Development Management Sub Committee

Wednesday 31 July 2019

**Application for Planning Permission 19/02377/FUL
At Boroughmuir High School, 111 Viewforth, Edinburgh
Proposed 5 storey extension to Boroughmuir High School,
including 12 new classrooms, community facilities,
ancillary accommodation, relocation of existing footpath,
alterations to external landscaping, and secure car park
compound (as amended).**

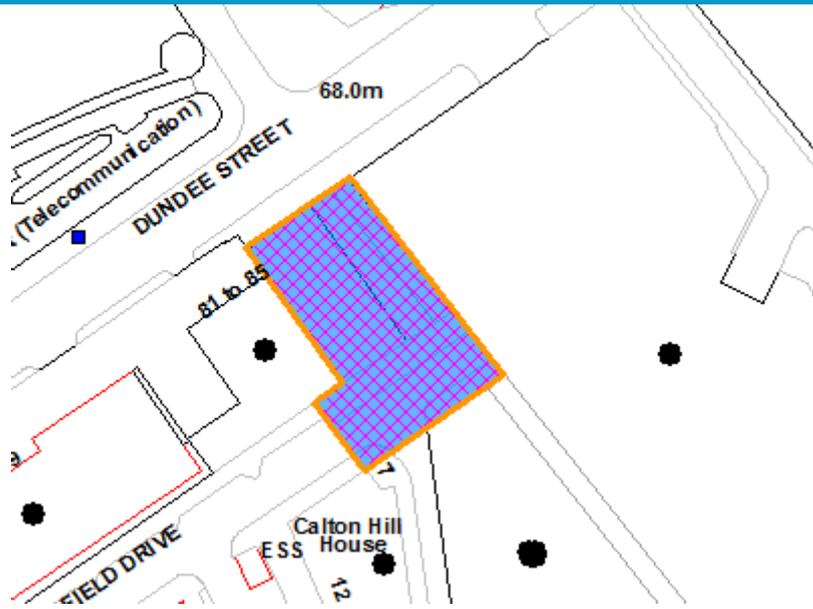
a) Revised site layout which shows increased provision of cycle parking to 34 new spaces. 10 no. at Dundee Street new entrance / 8 no. additional secure covered in playground / 16 no. additional on east side of building (this area is where previous approved application noted potential additional spaces).

b) A new 6m wide shared surface from Dundee Street to Bainsfield Drive (one-way road with footways on both side) is considered acceptable.

c) Refuse collection per existing arrangement.

d) Standard motorcycle parking space is 2mX0.8m
